Old Richardson Highway Intersection Improvements

Diagnostic Team Report

October 2019

Prepared For:
Alaska Department of
Transportation and Public
Facilities Northern Region

Figure 16: 8th Avenue Alternative – Bus Lane

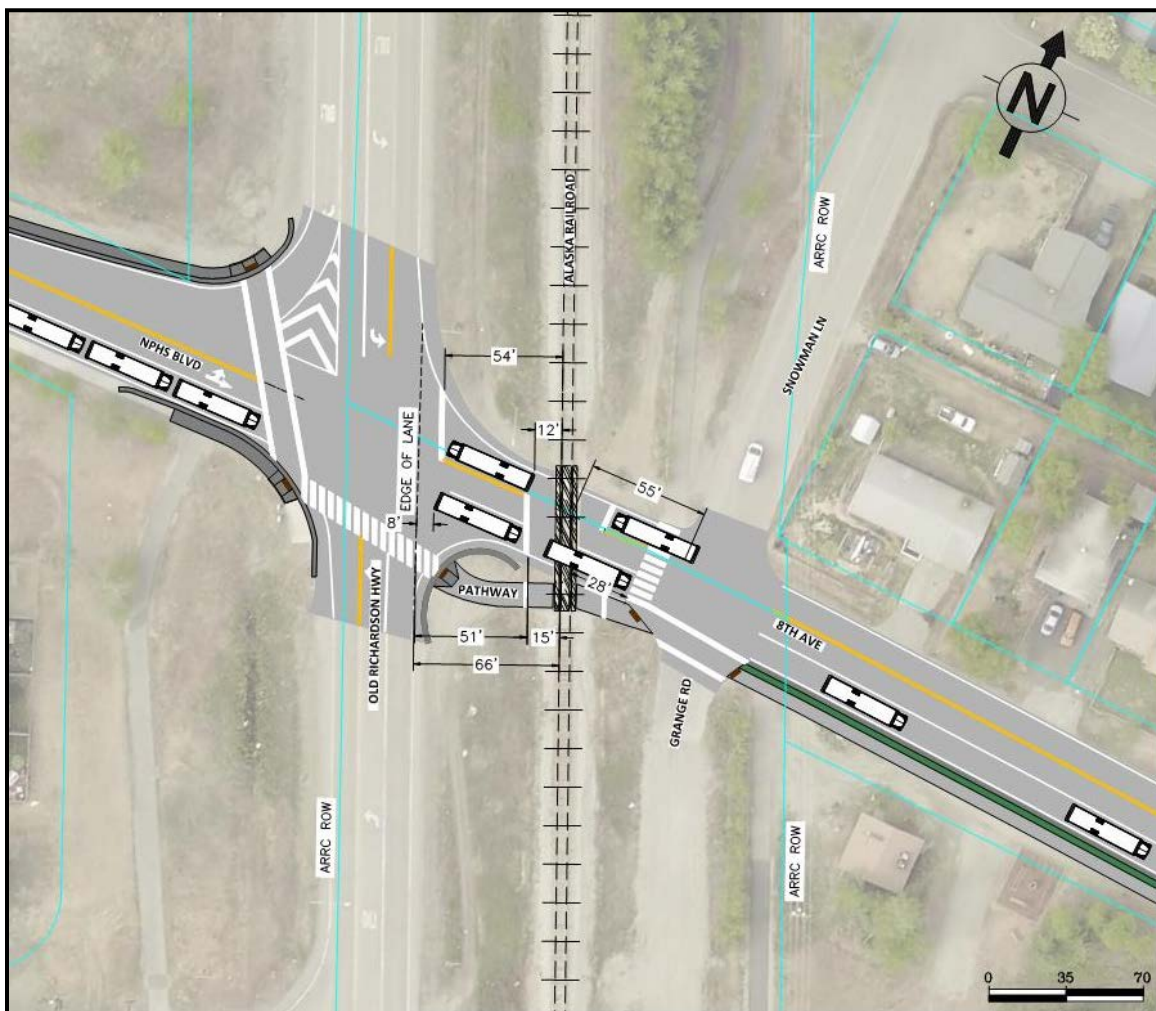
Another design alternative to improve bus queuing at the 8th Avenue-Old Richardson Highway intersection consists of constructing a bus lane from North Pole High School to North Pole Middle School. This alternative would increase the crossing width by one lane. All other components of the crossing would remain the same as the existing conditions. Multiple roadway lanes crossing a railroad track at a skewed approach with passive traffic control devices may induce conflict. Buses stopping at the crossing to perform their safety checks could block the sight distance from a vehicle in the adjacent lane to an oncoming train. Passive traffic control devices would not alert the driver of the approaching train. Skewed approaches exacerbate sight distance issues by requiring drivers to turn their head past comfortable limits for adequate line of sight. Therefore, the DT recommended performing an additional engineering analysis for installing active traffic protection (flashing lights and automatic gates) if this alternative is chosen. As with other 8th Avenue alternatives, they recommend relocating the cross walk on 8th Avenue, east of the crossing, to the east side of Snowman Lane to increase the vehicle storage adjacent to the tracks. Figure 16 shows the bus lane alternative as presented during the DT meeting.

<i>Condition</i>	<i>Deficiency</i>	<i>Recommendation and/or Comment</i>
Bus Lane	Passive traffic control for a multiple road lane crossing.	Multiple road lanes crossing a railroad track, at a skewed approach, with passive traffic control (yield signs) may induce conflict. Recommend performing an additional engineering analysis of active crossing protection if alternative is pursued.
